Client			Mr. J. McCarthy		
Project			2 Morlais Buildings High Street Merthyr Tydfil CF47 8UL		
Drawing Title			PROPOSALS		
CAD ref		Drawn		PRO	
Date		November 2019		Scale	
				1:50	
Project No.	9038	Drawing No.	02	Revision	C

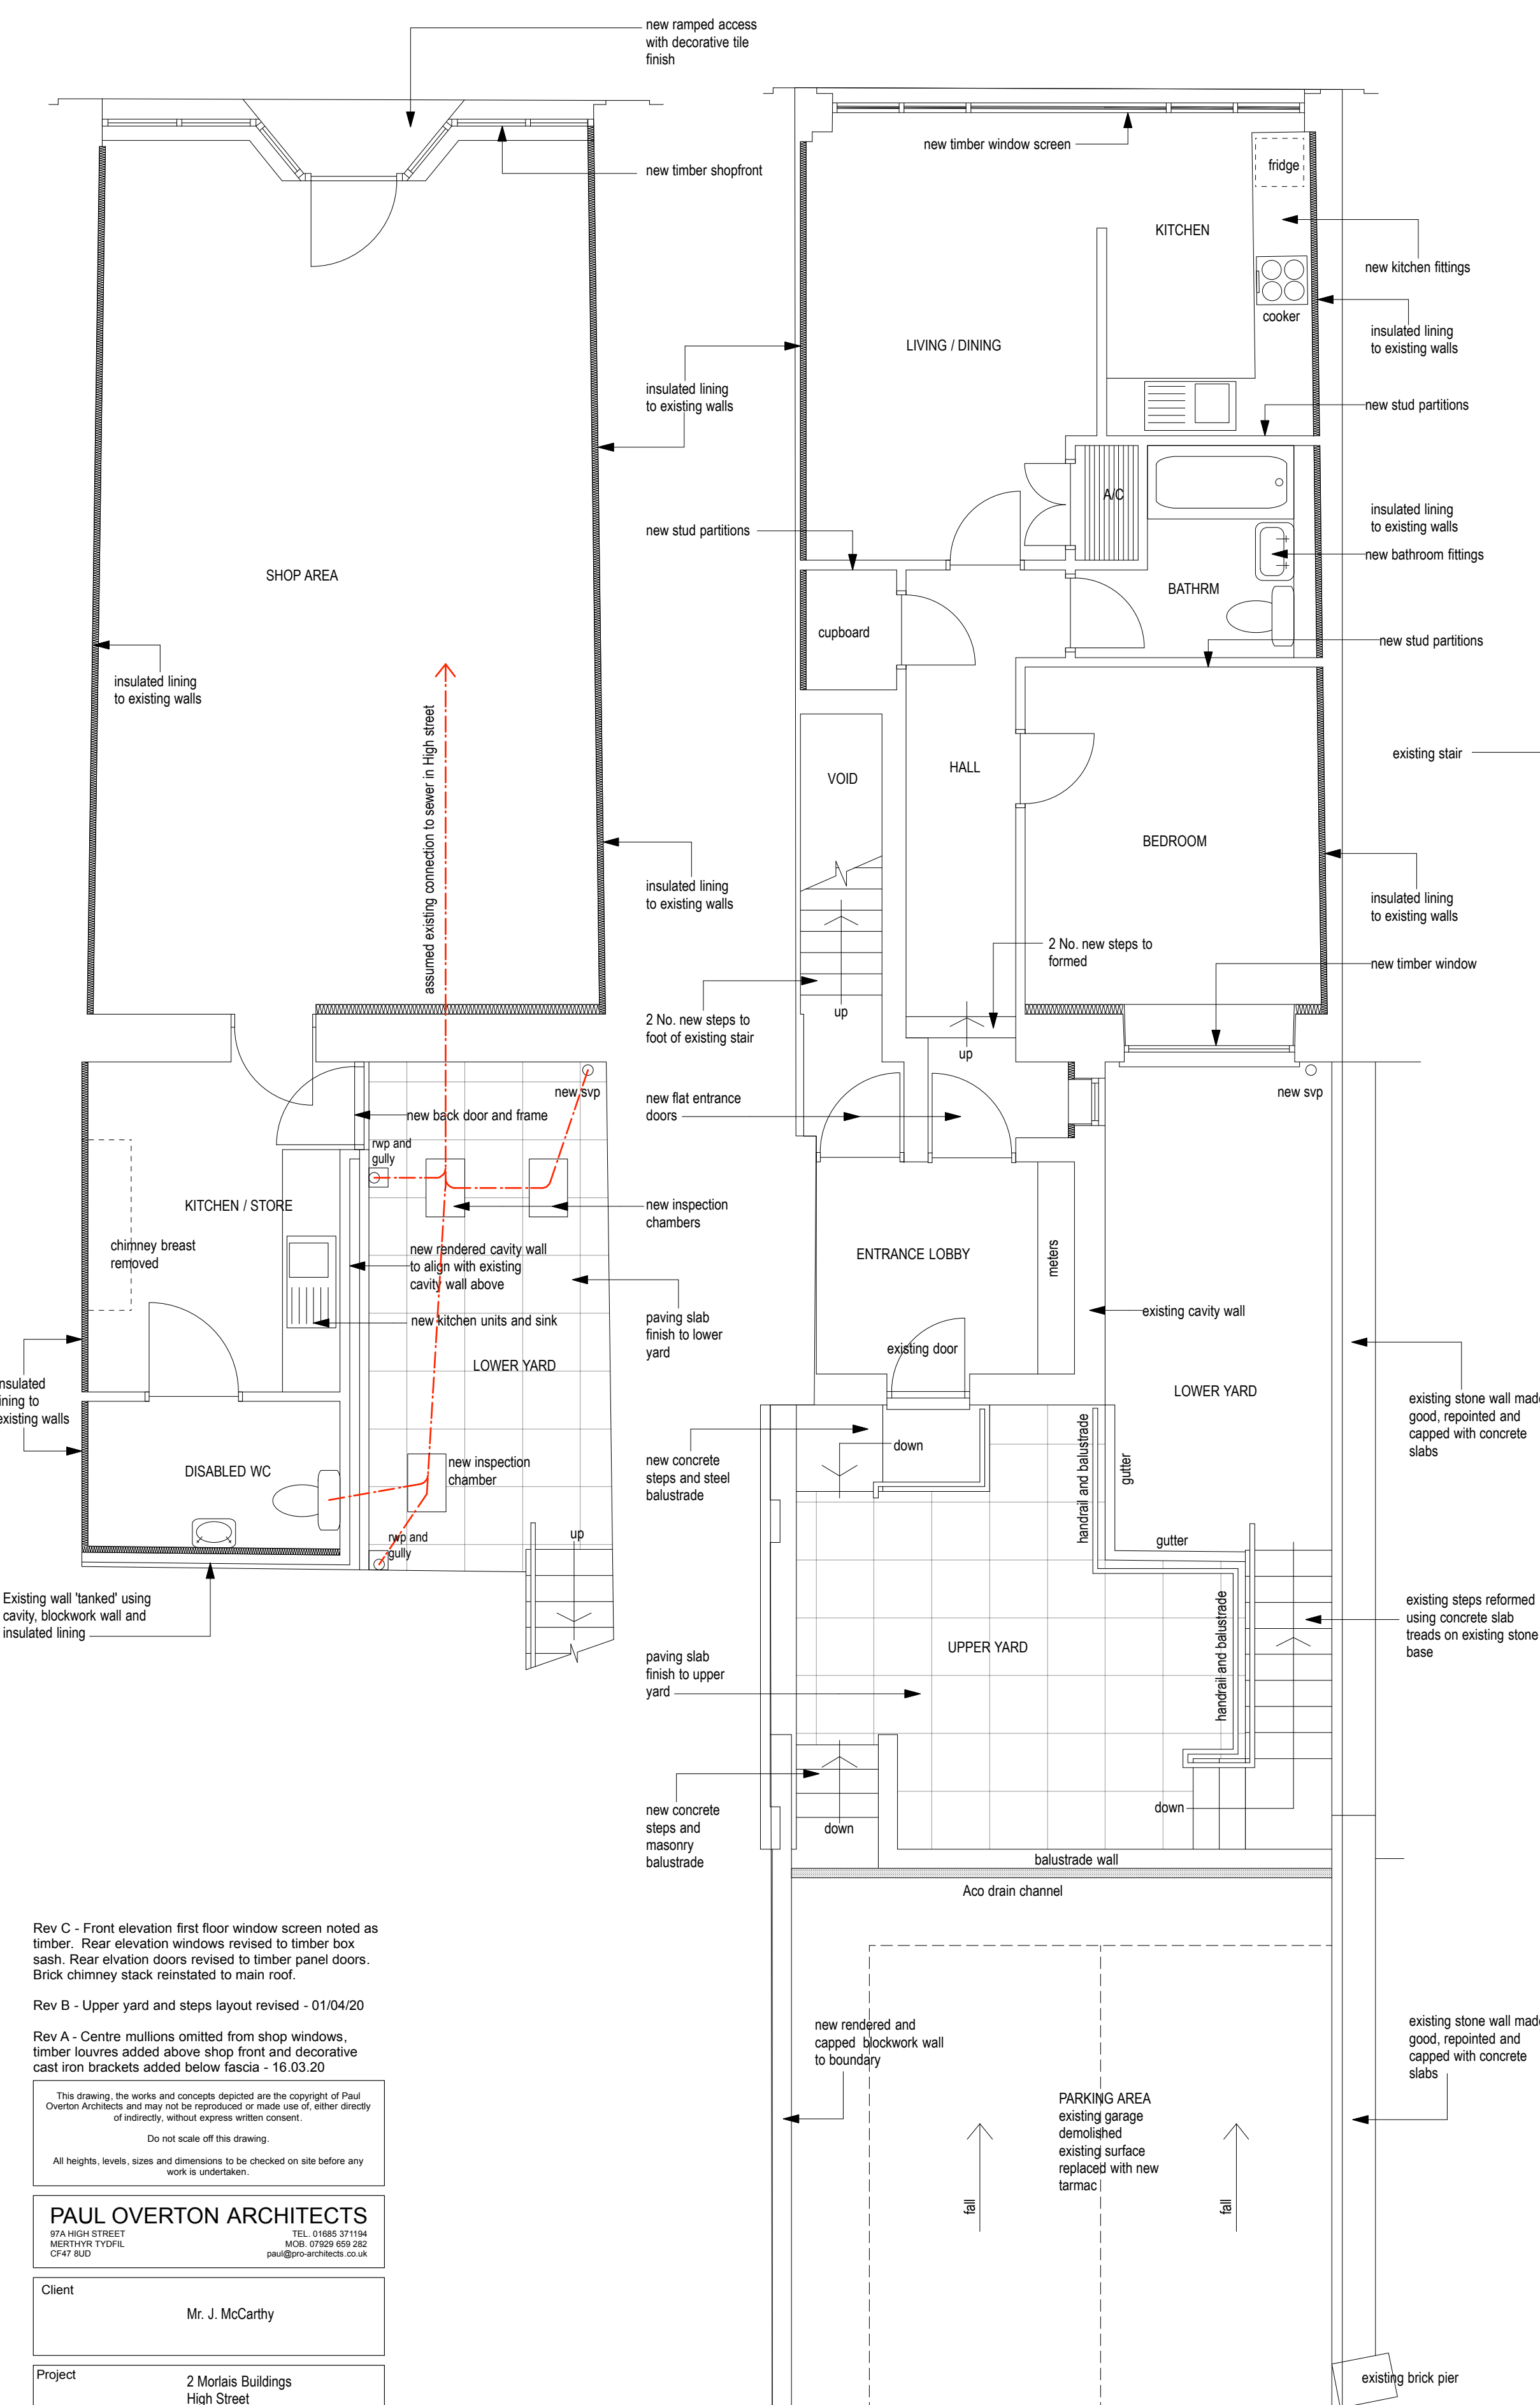
Rev C - Front elevation first floor window screen noted as timber. Rear elevation windows revised to timber box sash. Rear elevation doors revised to timber panel doors. Brick chimney stack reinstated to main roof.

Rev B - Upper yard and steps layout revised - 01/04/20

Rev A - Centre mullions omitted from shop windows, timber louvres added above shop front and decorative cast iron brackets added below fascia - 16.03.20
